Foxconn International Holdings Ltd.

Product Equality Declaration

N139DL FCCID: (2AJOTTA-1398) and N139DL FCCID: (2AJOTTA-1451) are same performance from certification point of view. to implement 2nd IC for WLAN and BT

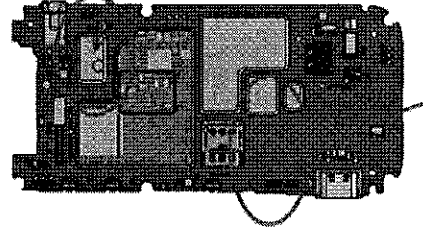
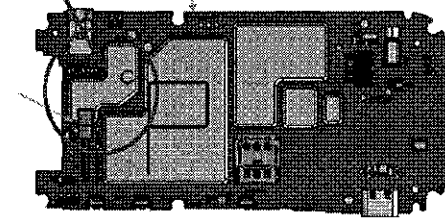
- HW change from FCCID 2AJOTTA-1398 to FCCID 2AJOTTA-1451 :
 - FM& SD card connector removed
 - WIFI & BT schematic design change, details refer to schematic of FCCID 2AJOTTA-1451. Page 35 change, and new add page 39.
 - WIFI & BT layout design change overview picture as below, HW0301 for FCCID 2AJOTTA-1398, HW0303 for FCCID 2AJOTTA-1451.

- BT and WIFI solution change, so key components change as below table.
